Model type:
WME12XIT

Commercial code:
F027230

Notices

FIG. 1

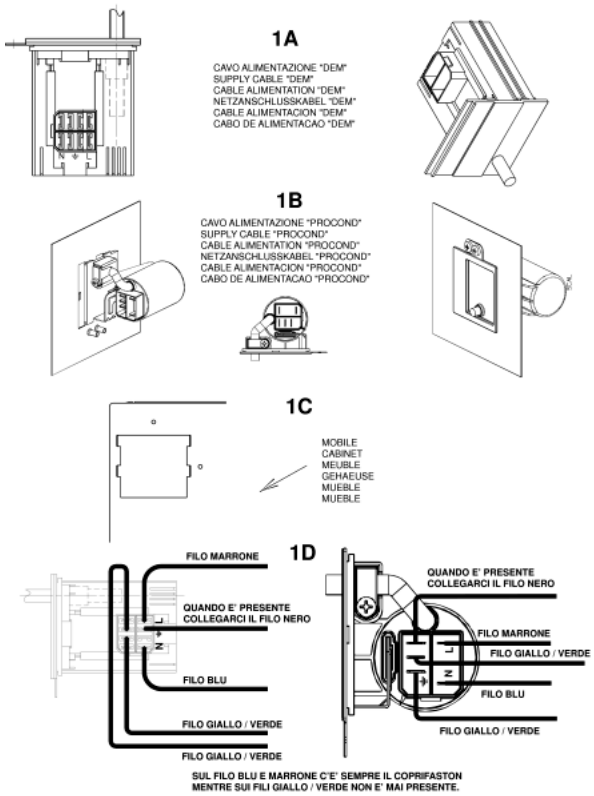
n1040276: Power supply cable + integrally moulded filter.

All appliances produced in the Comunanza (from serial no. 21008.0001), Teverola (from serial no. 21111.0001) and Brembate (from serial no. 21119.0001) factories have been equipped with power supply cables with integrally moulded filter (see fig.1 - 1A and 1B) and new units having a specific opening at the back for fixing the new cables (see fig. 1 - 1C).
The new units, together with the new cables, can be used in place of the premodification ones, by connecting the wiring to the cable, as shown in figure 1 - 1D.
The codes of the new units and of those replaced (ESI - table n1040276fig02), which will be managed until stocks run out, are given below.

IMPORTANT: the fixing / continuity screw is a specific self-scraping screw (code 092348) that ensures earth continuity between the filter and the unit. The same screw must be refitted in order to guarantee machine conformity.

The premodification wirings, are also managed for modified products by making the connection to the terminal block of the new cable as shown in fig. 1 - 1D.
The wiring diagrams given in the Documentation remain unchanged.

The new power supply cables are:
Code 091632 - Power supply cable 3x1 schuko 1.5m+capacitance filter;
Code 091633 - Power supply cable 3x1 schuko 1.5m+inductive filter;
Code 091634 - Power supply cable UK 3x1 l= 1950mm + inductive filter;
Code 091635 - Power supply cable UK 3x1 l=1950mm+capacitance filter;
Code 091636 - Power supply cable l=2.55m AUS+inductive filter;
Code 091641 - Power supply cable l=2550mm AG +capacitance filter;
Code 091642 - Power supply cable 1.85mt SHUKO no inductive filter;
Code 091643 - Power supply cable 3x1 (CH) 1.5m+inductive filter;
Code 091645 - Power supply cable 3450mm SOUTH AF.+capacitance filter;
Code 091690 - Power supply cable shuko l2.55m KOREA+inductive filter;
Code 091689 - Power Supply cable l=2550mm AG+inductive filter.

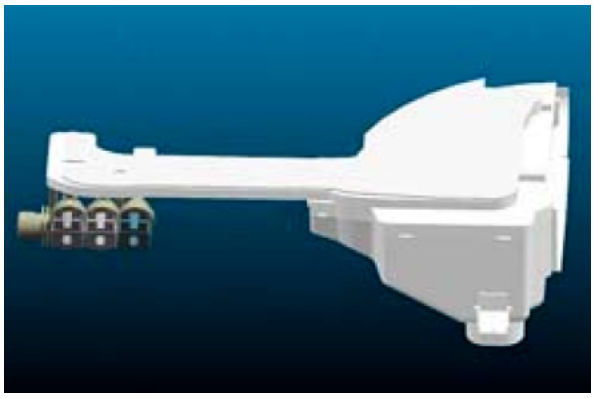
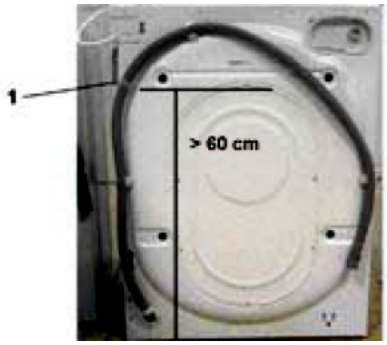
n1040282: New drainage OKO system.

From serial number 21219.0001, the new "OKO" drainage system has been introduced on the washing machines produced in the Comunanza factory.

- EEPROM (the OKO system requires a new setting of load timing parameters). THE NEW EEPROMS REPLACE ALL THE ONES CODED PREVIOUSLY.
- BOWL (hopper tube hole shifted forwards);
- DETERGENT LOADING TUBE (see fig. 1);
- PRESSURE SWITCH (changed levels);
- OKO PUMP BOWL BLOWER + BALL (see fig. 2A, 2B and 2C);
- CONDUCTIVITY SENSOR (if provided, it is shorter than the premodification item);
- DRAIN PUMP (without detergent collecting tube connection);
- HOPPER (shifted in front of detergent loading tube connection). Fig. 3A post-modification. Fig. 3B premodification);
- AIR TRAP (different shape);
- PRESSURE SWITCH TUBE (different length);
- DRAIN TUBE STOP (specific);

In particular, the OKO system consists of a spherical plastic component inserted in the tube that connects the bowl to the drain pump (see fig.2 A).
At the beginning of each wash cycle the washing machine fills water for 10 seconds and activates the drain pump for 2 seconds. In this way, the water level in the bowl is different from that in the drain tube; this difference increases the thrust of the ball upwards, closing the bowl-pump connection tube hermetically (see fig. 2D).
This system has the double advantage of:

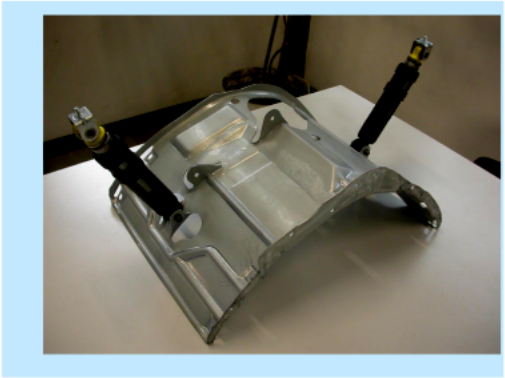
n1040325: New shock absorber fixing system with pin

From serial no. 40427.0001, shock absorbers have been fixed to the tank unit cradle with two 11 mm pins code C00110163 (see fig. 01 and 02 enclosed) in place of the 8 mm screws code 093750 and relevant locking nuts code 030443, on all washing machines and dryers produced in the Comunanza factory.
The items affected by this modification are:

2) The new shock absorbers, with fixing bushing having no s/steel spacer, are not managed as they are interchangeable with the premodified items (make sure they are CIMA type, as the managed items), fixed with M8 screws code 093750 and related locking nut code 030443 (see figs. 05 and 06).
Code 093884 - Shock absorber 80 N
Code 093885 - Shock absorber 100 N

To remove the shock absorber from the tank, first extract the pin with a few hammer taps (see fig.03) until it is aligned with the tank bracket and then pull it out with a pair of pliers (see fig. 04).
(To refit the shock absorber use a new pin. Insert the pin until the toroidal edge is aligned with the bracket.)

Fig . 001

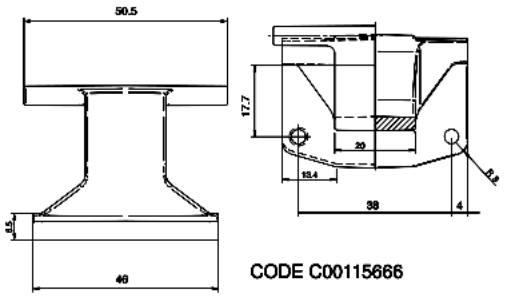
n1040349: Introduction of 150° Zamac hinge on Ariston 46 models.

From serial no. 50207.0001, all Ariston models produced in the Teverola factory (see table 001 attached) with industrial code (given on the rating plate) starting with 46, have been equipped with a Zamac hinge with 150° opening angle, code C00115666

(see Fig.001).
This modification has involved the introduction of the following items:

Code C00115670 - Complete door EVOII 150° white 27 with standard glass;
Code C00115674 - Complete door EVOII 150° white 27 with long glass;
Code C00115667 - EVOII body for 150° hinge white 27;

The premodified items are not interchangeable separately with the modified ones.
